Well Name: ROPCO 4	Well Location: T29N / R14W / SEC 4 / NESE / 36.752719 / -108.308409	County or Parish/State: SAN JUAN / NM
Well Number: 2	Type of Well: CONVENTIONAL GAS WELL	Allottee or Tribe Name:
Lease Number: NMSF079968	Unit or CA Name:	Unit or CA Number:
US Well Number: 3004530422	Well Status: Temporarily Abandoned	Operator: HILCORP ENERGY COMPANY

Sundry ID: 2708144

**HILCORP ENERGY COMPANY**  
**Ropco 4 2**  
**NOTICE OF INTENT TO PERMANENTLY ABANDON**

**CONDITIONS OF APPROVAL**

**Ropco 4 2 - PROPOSED P&A SCHEMATIC**

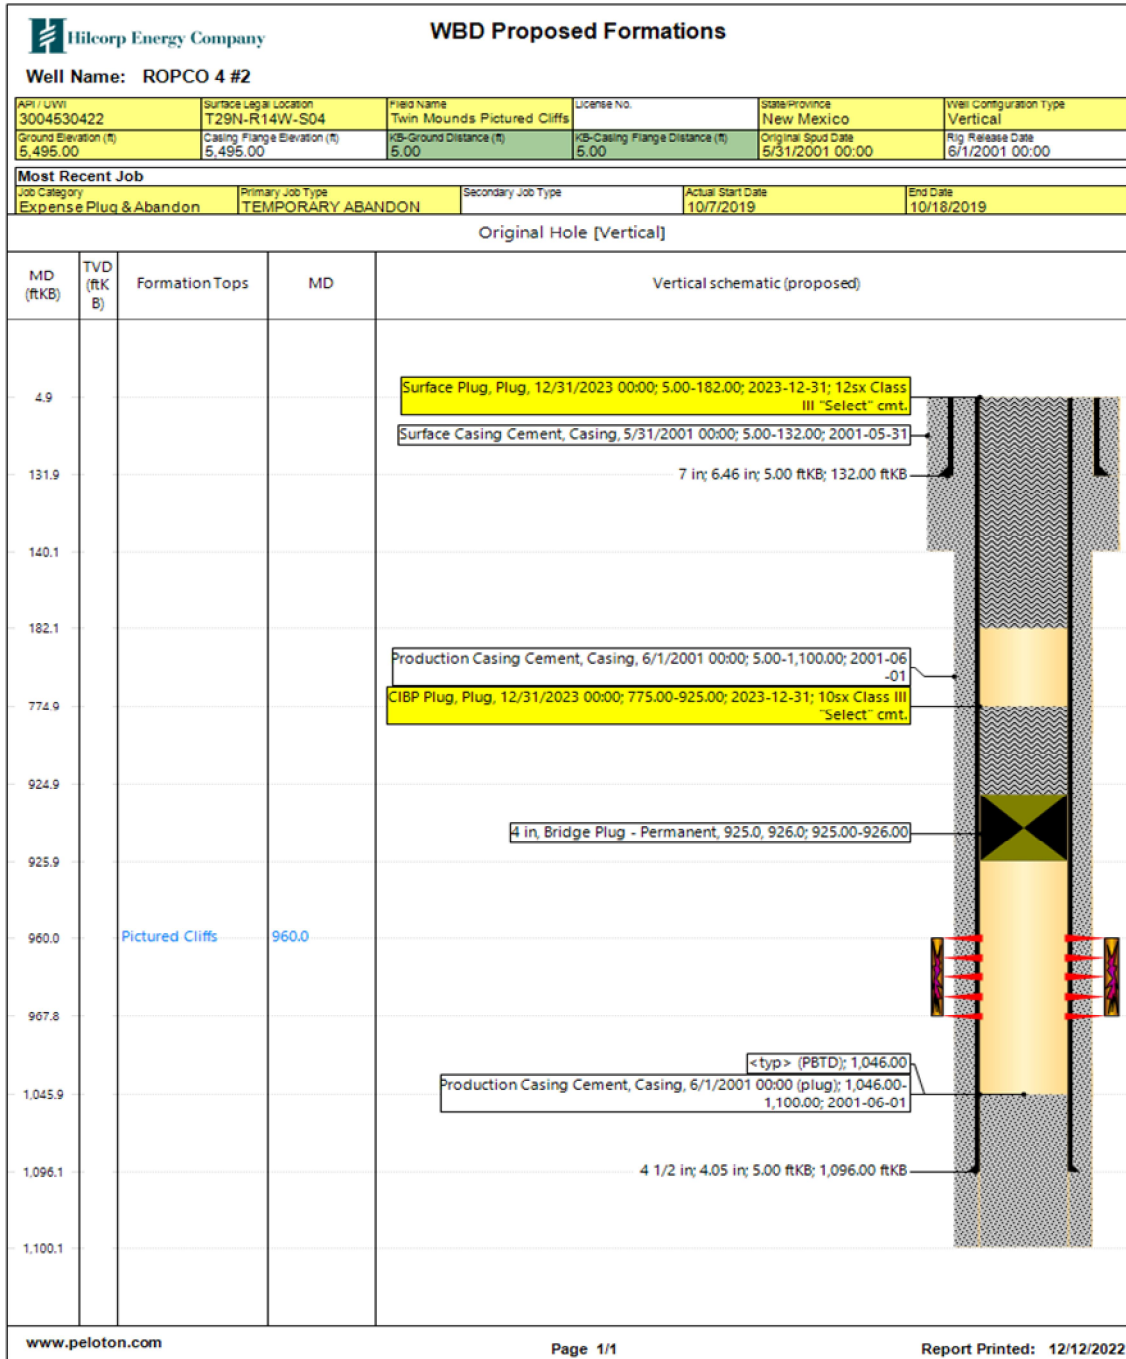
1. Plugging operations authorized are subject to the attached "General Requirements for Permanent Abandonment of Wells on Federal and Indian Lease."
2. The following modifications to your plugging program are to be made:
  - a. Add a plug to cover BLM estimate for the Fruitland formation top at 590'.
3. Farmington Office is to be notified at least 24 hours before the plugging operations commence at (505) 564-7750.

- Add a plug to cover BLM estimate for the Fruitland formation top at 590'.
